TECHNICAL SERVICE BULLETIN

NO. 72-A-6

ENGINE OIL CAPACITY

MGB

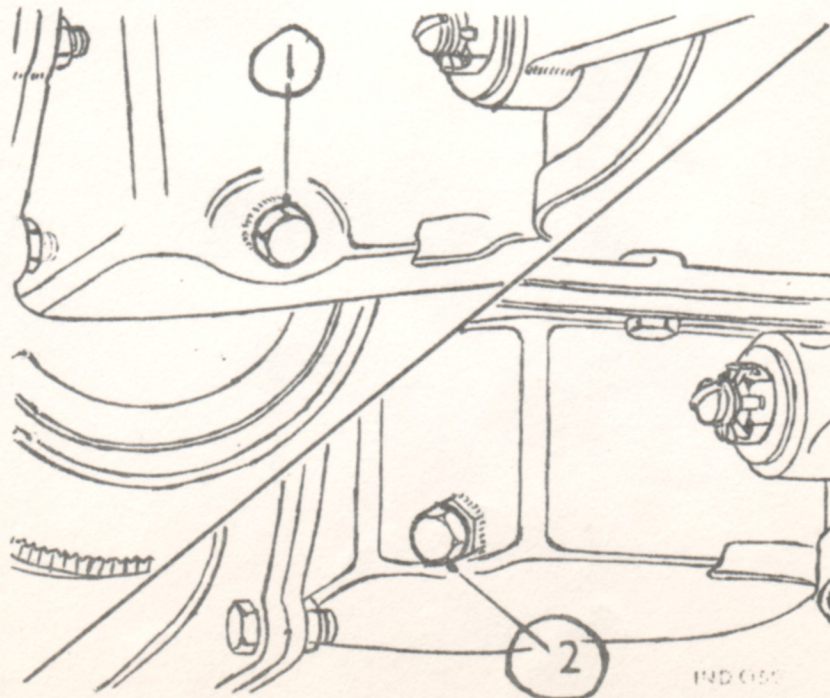
During the latter part of 1971, a modified engine sump was fitted which reduced the engine oil capacity on this model by approximately 1 1/2 U.S. pints. In order to clear up any misunderstanding, the following capacities are applicable:

The old versus the new type sumps are shown below in illustrations 1 and 2, respectively.

<u>Early Type Sump</u>	<u>Modified Sump</u>
Engine:	8.5 U.S. Pints	6.9 U.S. Pints
Oil Filter:	0.6 U.S. Pints	0.6 U.S. Pints
Oil Cooler:	0.9 U.S. Pints	0.9 U.S. Pints
